DETAILED ACTION

Claims 1, 6, 9-14, 21, and 26-27 are rejected under 35 U.S.C. 103(a) as being unpatentable over Tanaka et al (US Patent 4,934,836) in view of Moritan (US Patent 5,715,116).

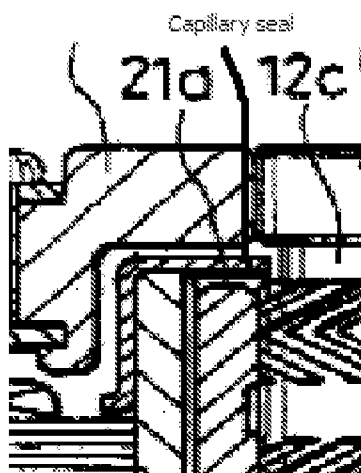
Moritan teaches a fluid dynamic bearing motor with a a capillary seal between the shaft and the liner having a close mating relationship end in fluid communication with the fluid dynamic bearing and an opposing diverging mating relationship end defining an inlet reservoir (fig. 1c, see below)

And a channel (23b) outside the liner (21), extending along the bottom and the longitudinal wall (the channel begins at reference 21' and proceeds along the bottom of

the liner and the longitudinal wall), for the purpose of permitting smooth assembly of the motor (col. 8, lines 50-51).

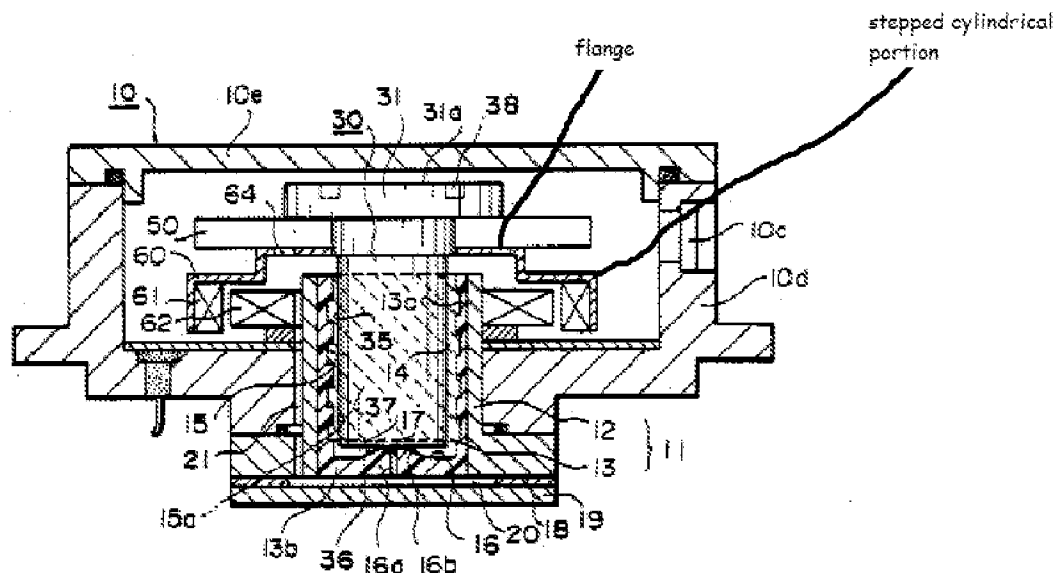
Regarding claim 13, the hub further includes a flange and a stepped cylindrical sidewall extending from the flange and circumscribing at least a portion of the base (see figure below).
